Goring Parish Council: GNP6 Planning Application Assessment

Assessed by	Name: Goring Parish Council Date: December 2020
Planning reference number	P20/S24488/FUL
Summary of application	GNP6 Revised Full Planning Application

This form assesses the revised planning application for GNP6 against the policies of the Neighbourhood Plan. It provides a comprehensive assessment to assist SODC identify the areas of compliance and non-compliance and where additional information is required. It includes GPC's previous consultation comments and new additional comments.

Diagram of detailed sightlines for GNP6

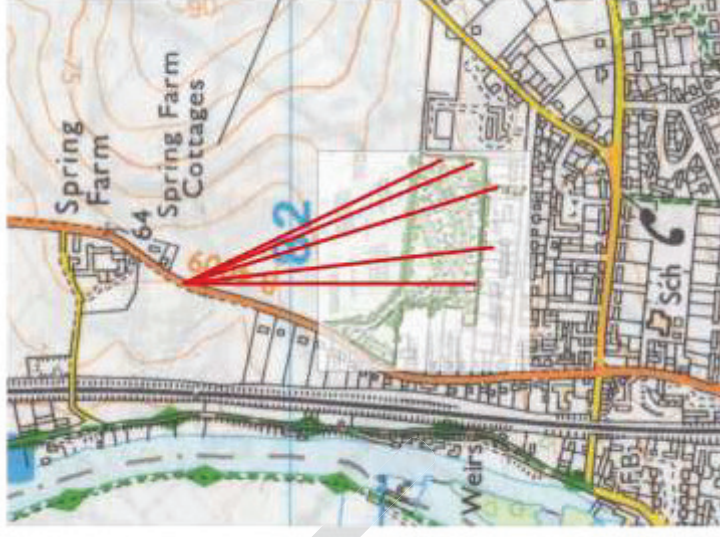
<p>N</p>		<p>N</p>	<p>Comments to the left still apply.</p> <p>The required series of cross-sections required by the NP and by SODC in the Pre-App report have still not been provided.</p> <p>Policy 08. SSR5 in the Plan states: <i>“Detailed cross sections should be taken along a series of sightlines including but not limited to those shown on the plan (below) to ensure this condition is met.”</i></p>

Views are dynamic and change with position so several cross sections are required as the Bramhill LVIA Supplementary Report 1 para 85 comments:
